Access Design Assessment Report

Stage 1 - Warnervale Primary School

Project: Stage 1 - Warnervale Primary School
 Document Type: Access Design Assessment Report
 Report Number: P218_016-3 (ACCESS) NH

Figure 1 – Site plan

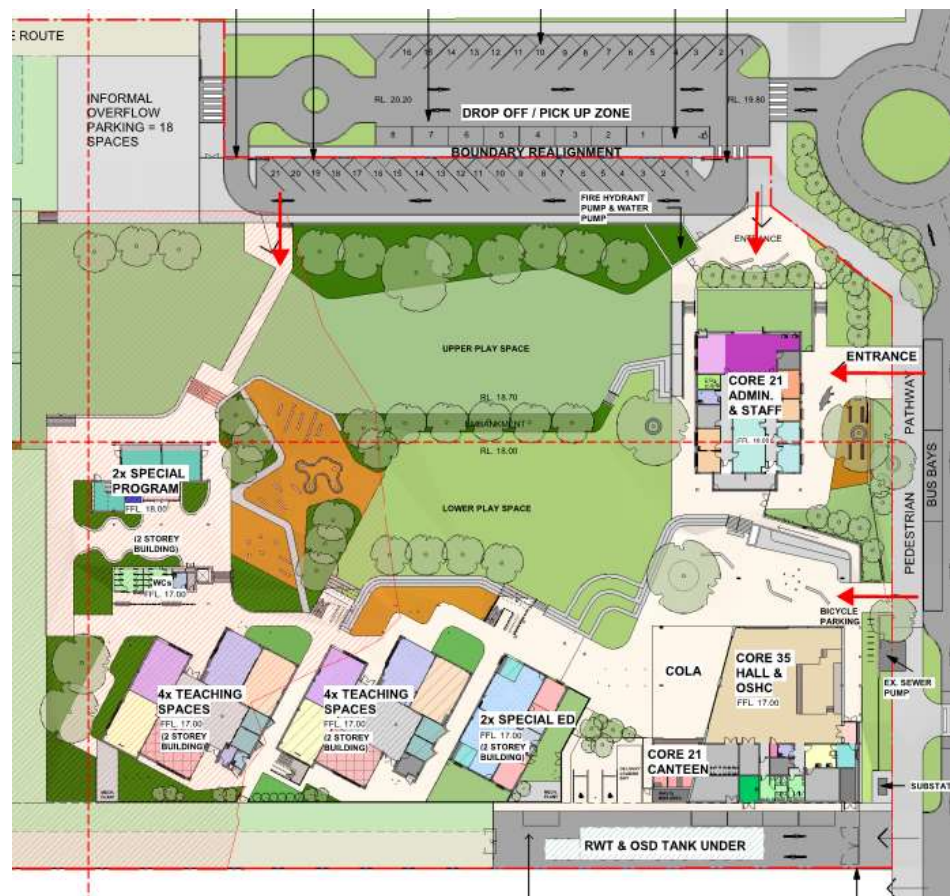
- (i) The following rooms / areas and associated accessways have been afforded the concession under D3.4 and access for people with disabilities need not be provided to these areas—
- Storage room/s;
 - Plant and equipment room/s.
- (ii) The school has not been treated as being provided with fixed seating;
- (iii) The pedestrian entrances to the school have been assessed as being located as per the figure below.
